Planning Review By: Desirae Mayo, Phone: (480) 312-4218, e-mail: DMayo@scottsdaleaz.gov, Review Cycle: 1, Date: 12/21/2021

Zebra responses to each comment are shown in blue, as they relate to the Revision 1 drawing set, dated 01/13/22.

POTTERY BARN

MPE Review By: Jim Pappas - 480-312-7942 jpappas@scottsdaleaz.gov

SHEET NO.: **A201**

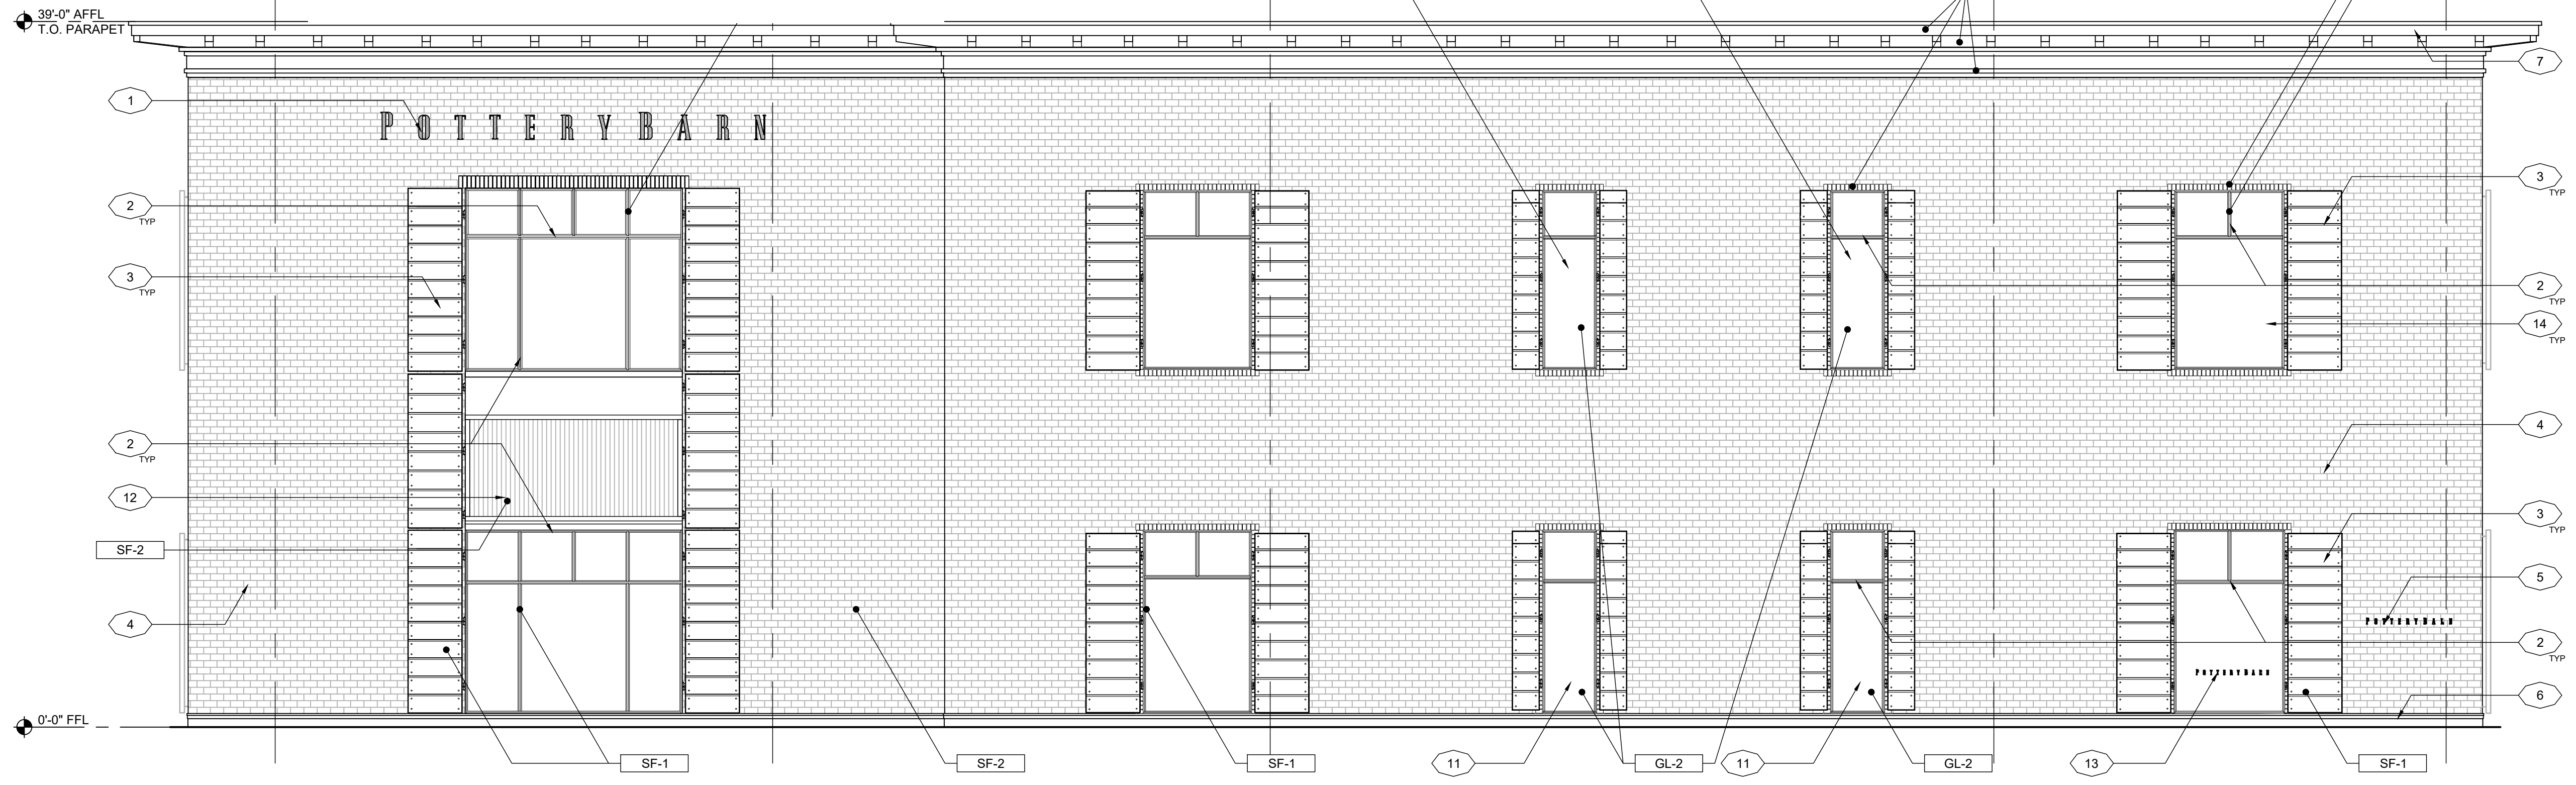
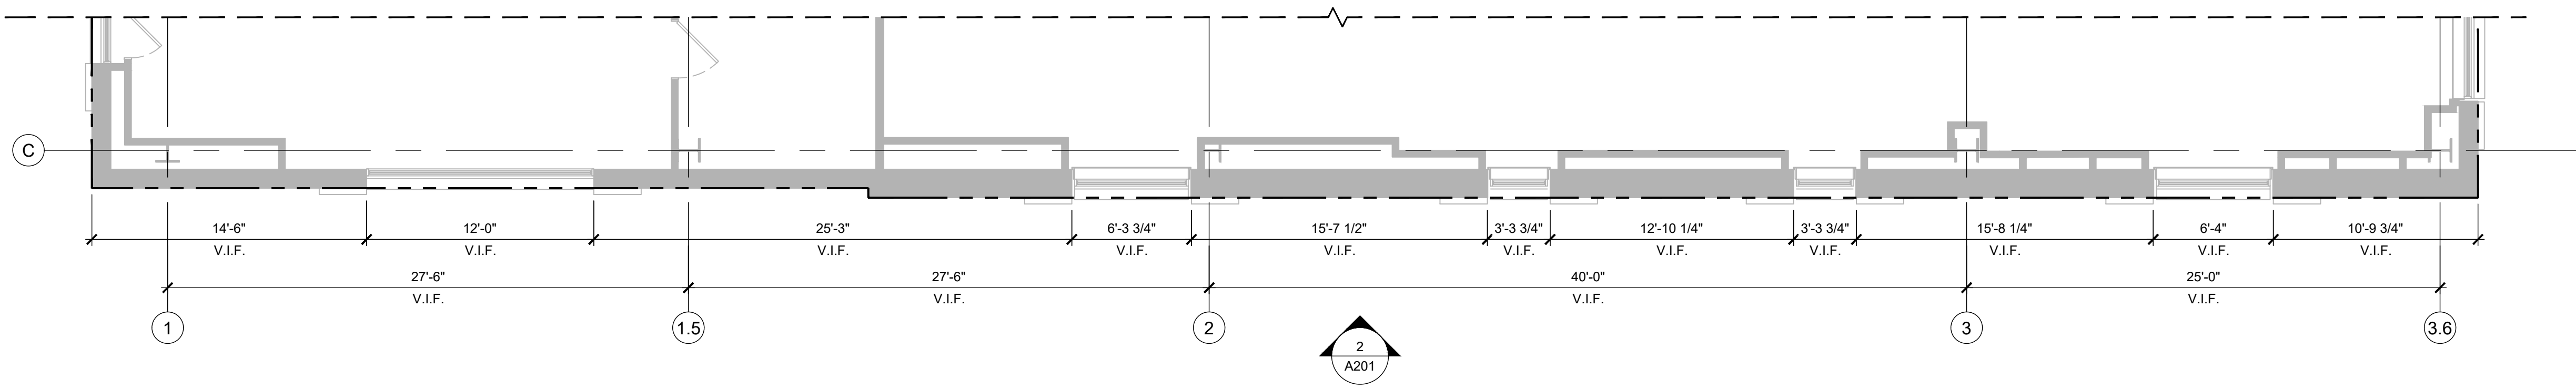
note: paint LRV must be less than 70%. proposed storefront facade paint color is 87% LRV and would not be supported by staff for a staff approval.

add that signs to be done under separate permit

are awnings being removed or replaced? verify. awnings should remain to provide shade for pedestrians.

ZBR: refer to revised sheets A201, A202 and A203. Alabaster 876 has been revised to Fog Mist OC-31, with an LRV of 71.6. 71.6 was confirmed acceptable by Brad Carr on 01/11/22.

ZBR: refer to revised sheets A201, A202 and A203. This has been added to the keynotes.

ZBR: refer to revised sheets A041, A042, A201, A202 and A203. Awnings on the East and West facades have been revised to remain. Awnings on the south facade are still being removed, due to the adequate tree coverage on that side of the street, as approved by Brad Carr on 01/11/22.

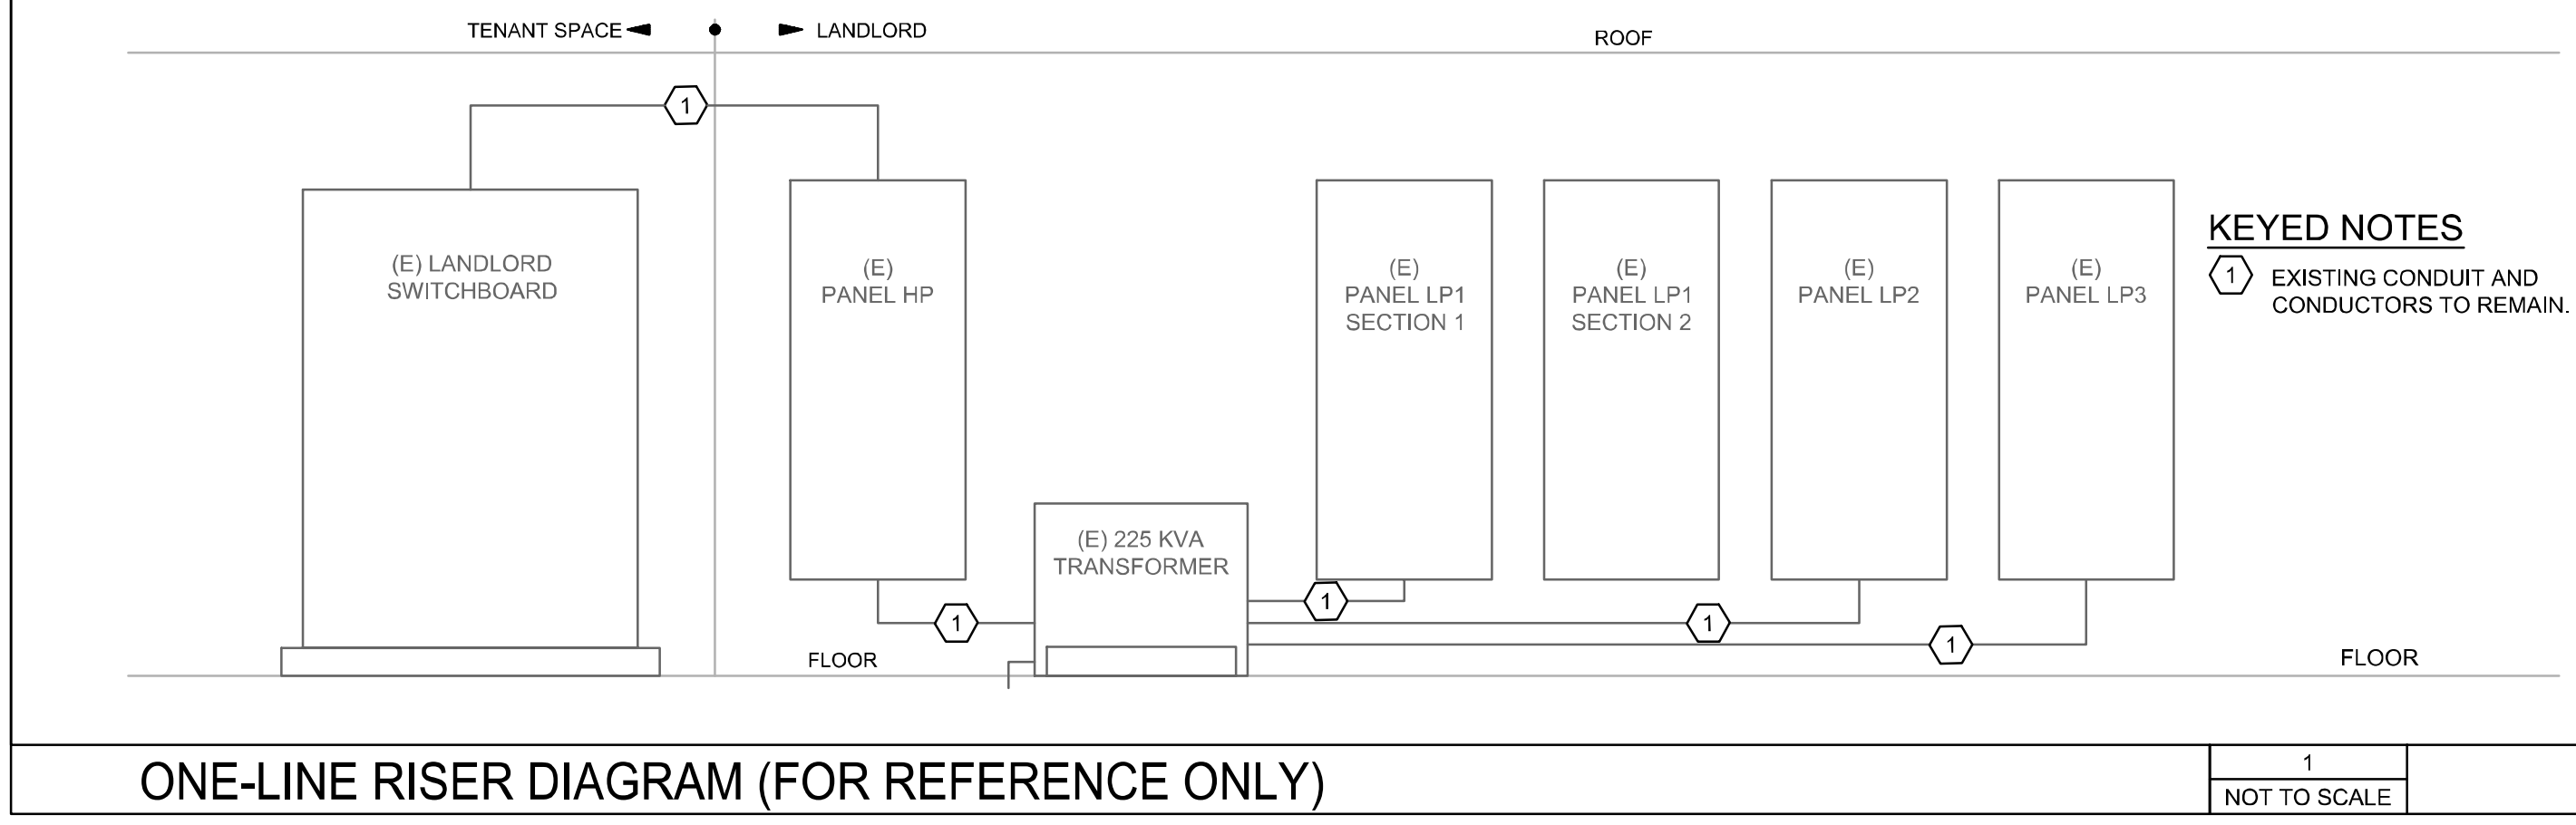
Per NEC 408.4 (A): "Every circuit and circuit modification shall be legibly identified as to its CLEAR, EVIDENT, AND SPECIFIC PURPOSE OR USE."
